NAC INTERNATIONAL

REQUEST FOR ADDITIONAL INFORMATION

NAC UNIVERSAL TRANSPORT SYSTEM (NAC-UMS®)

SAR SUBMITTAL – REVISION UMST-01D

Figure RAI 2.9-1 Dynamic Load Factor for Single Degree of Freedom System – Triangular
Pulse Shape, No Damping

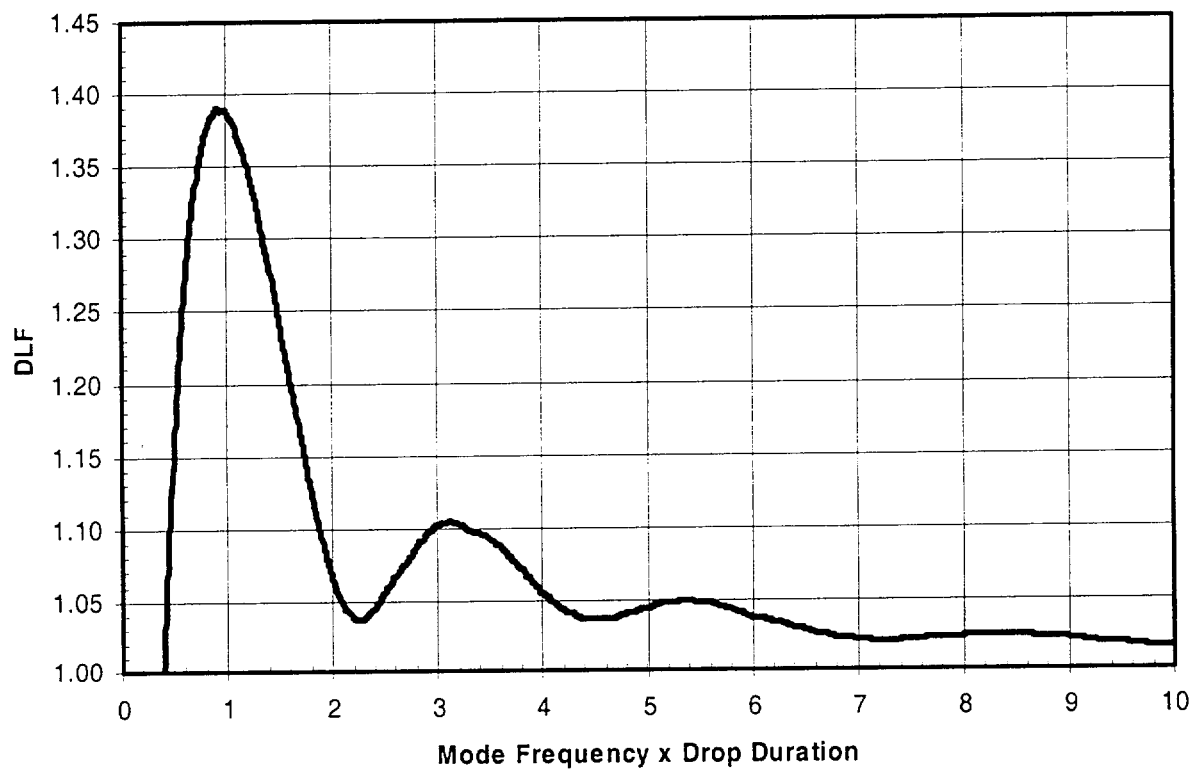
- 2-9 With respect to SAR Figures 2.6.7.5-5, -6, and -7, provide an evaluation of effects of vibratory response components on the maximum decelerations as presented in Table 2.6.7.5-6.

The staff recognizes the need for low-pass filtering both the test and calculated results for removing spurious, high frequency, response components which are inherent to the numerical modeling but non-consequential for practical cask design consideration. The staff notes that rigid body response components are generally considered for benchmarking a cask/impact limiter finite element analysis model. However, to determine peak cask decelerations by either testing or analysis, contributions from vibratory response components, which would be associated with predominant cask vibration modes of interest, should also be properly considered. Complete and accurate information should be provided, per Section 71.1(a), for evaluating the package free-drop performance under Sections 71.71(c)(7) and 71.73(c)(1).

To determine the predominant cask vibration modes of interest, a modal analysis of the basket support disks was performed using the ANSYS program that calculates the frequencies for the side drop for the BWR and PWR baskets for the end drops and side drops. To determine the dynamic load factor (DLF), the side drop and end drop are treated as single degree of freedom systems with triangular pulse shape and no damping. Figure RAI 2.9-1 plots the DLF verses the mode frequency times the drop duration for a triangular pulse shape. The following table summarizes the DLF for each orientation.

In all cases, the factored accelerations that include the effects of the cask vibratory response are less than the design accelerations employed in the evaluation of the UMS[®] cask.

Figure RAI 2.11-1 Comparison of Quarter-Scale Model Side Drop (LS-DYNA and Drop Test) Results (Upper Accelerometer)

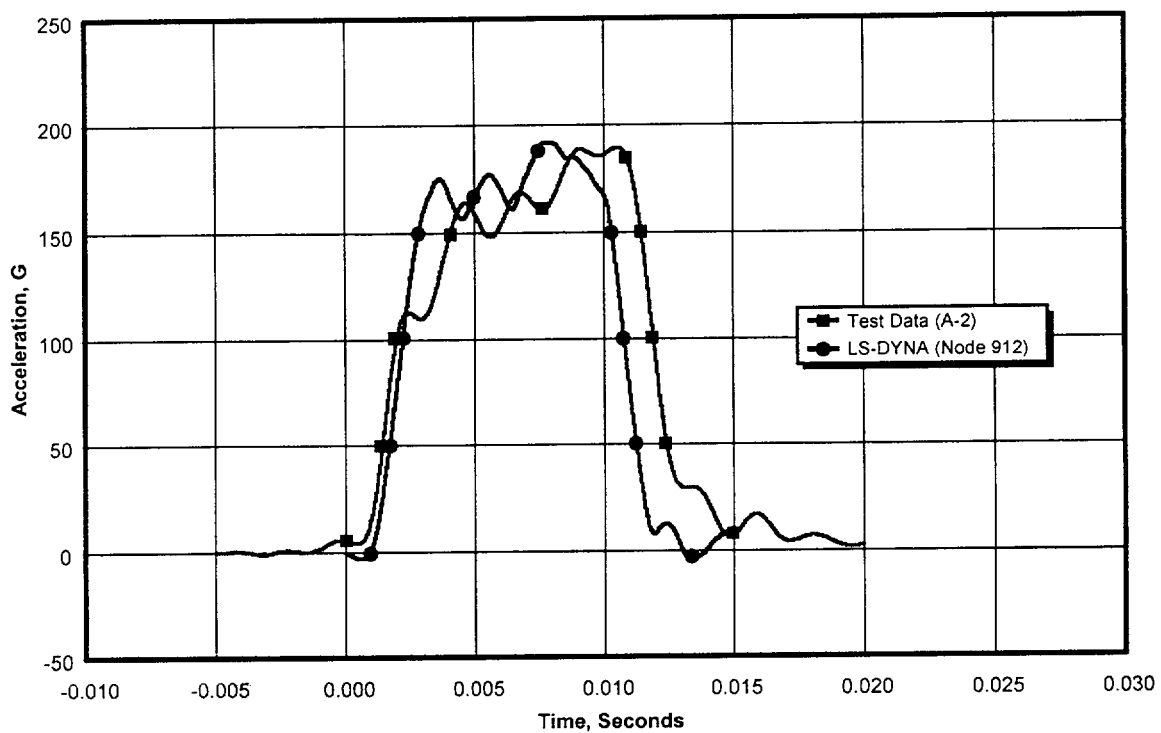
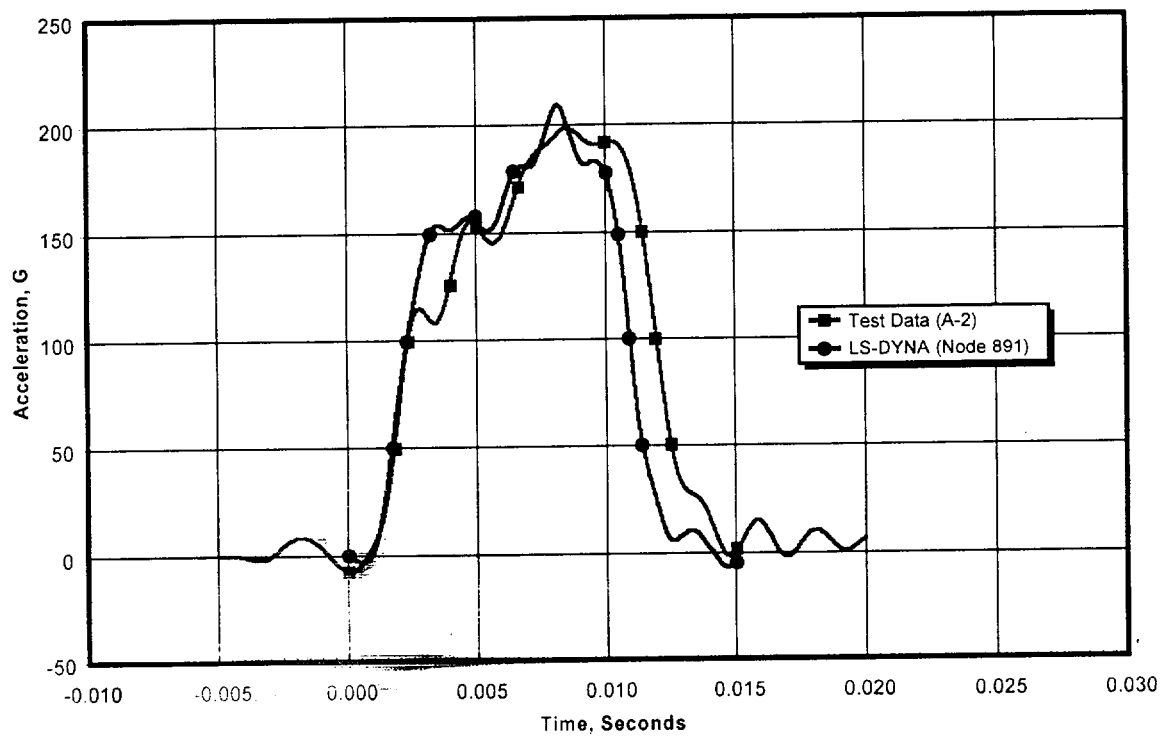
- 2-11 With respect to Figures 2.10.3-8 and -9, explain why the LS-DYNA calculated and low-pass filtered deceleration time histories do not contain similar vibratory response components to those recorded for the side drop test.

The staff notes that both the analysis and test raw data were reduced with the same low-pass filtering parameters. As such, the analysis results are expected to display also the vibratory response components superimposed on the rigid body cask responses. Complete and accurate information should be provided, per Section 71.1(a), for evaluating the package free-drop performance under Sections 71.71(c)(7) and 71.73(c)(1).

The vibratory response noted in the test data is a direct result of the sampling rate at which the data was recorded. The sampling rate used by Sandia National Laboratories during the quarter-scale model side drop test was approximately 250,000 Hz, which results in a data point being recorded every 1/250,000 seconds and reduces the effectiveness of the Butterworth filter. Typical LS-DYNA analyses are performed with sampling rates from 50,000 to 100,000 Hz. For the purposes of this evaluation, the data rate in LS-DYNA was increased to 250,000 Hz. Figures RAI 2.11-1 and RAI 2.11-2 provide the comparison of the analysis and test data with the 250,000 Hz sampling rate. Both curves are filtered at 450 Hz. Figures 2.10.3-8 and -9 have been updated with the new results. The updated curves show similar frequency content in terms of the oscillatory behavior.
